FOUNDATION INVESTIGATION REPORT BY:
Geecon, Limited, Toronto, Ontario -
Proposed Blair Road Overpass, Ottawa
W.P. 911-64 -- District. No. 9

Re: Soil Conditions and Foundations
Proposed Blair Road Overpass
W.P. 911-64
Ottawa, Ontario

SUBJECT: W.P. 911-64 Site #3-221
Blair Road Interchange Underpass
East of Ottawa East Limits
Highway #17 District #9.

W.P. 911-64, Site #3-221,
Blair Road Interchange Underpass,
East of Ottawa East Limits,
Hwy. #17, District #9 (Ottawa).

| D5607-P-1 | |

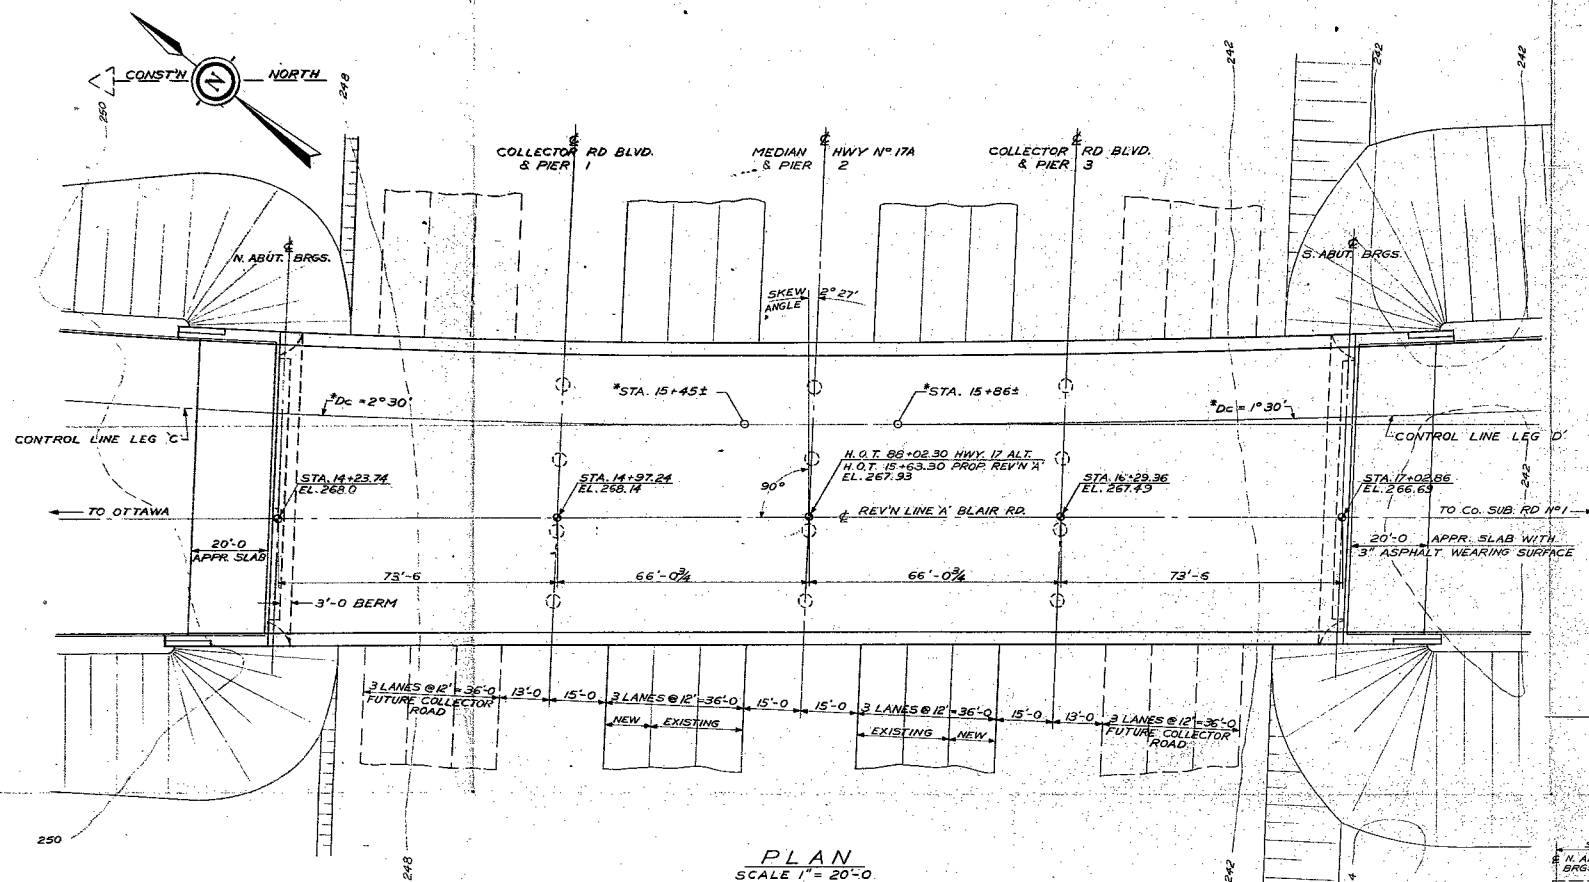
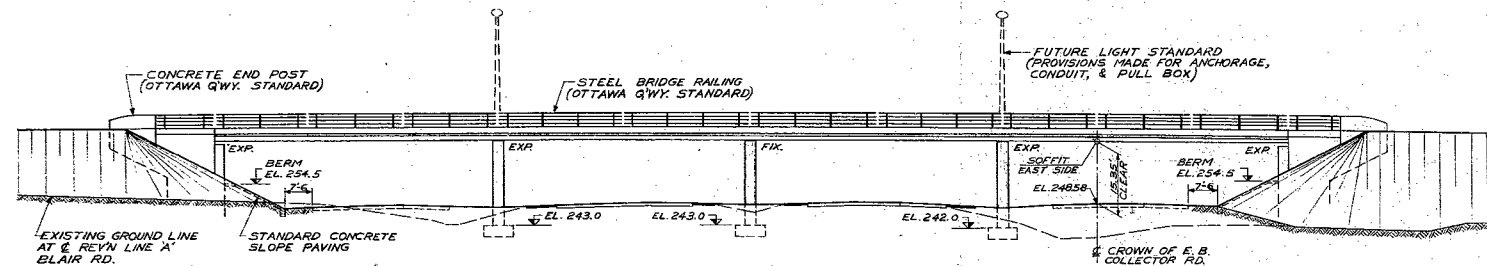
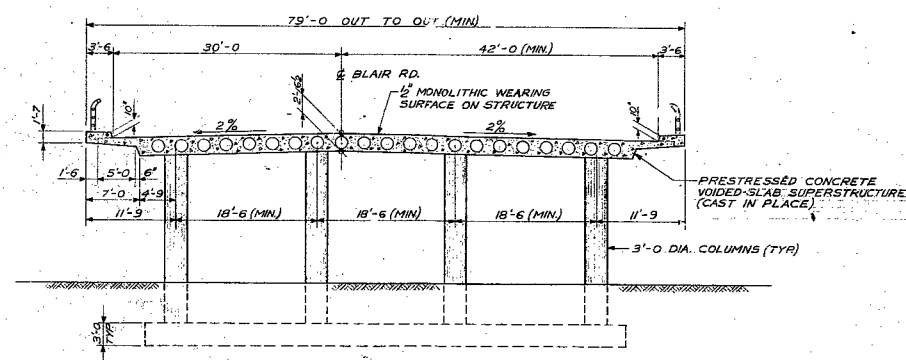
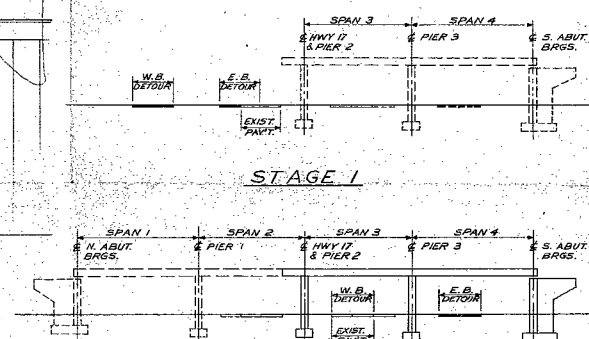
Enclosed please find one copy of the preliminary plan
D-5607-P1 for the above structure.

Would you kindly review the bridge foundations
proposed and inform us if they are satisfactory.

North Abut. Ftg Bottom :- el. 241.0
South Abut Ftg. Bottom :- el. 237.0

We have reviewed the proposed bridge foundations
for Blair Road interchange underpass.

The designed footings are in accordance with the
recommendations. It is understood that the bottom elevation
of the North abutment footing is at El. 241.0, and the South
abutment footing is at El. 237.0.
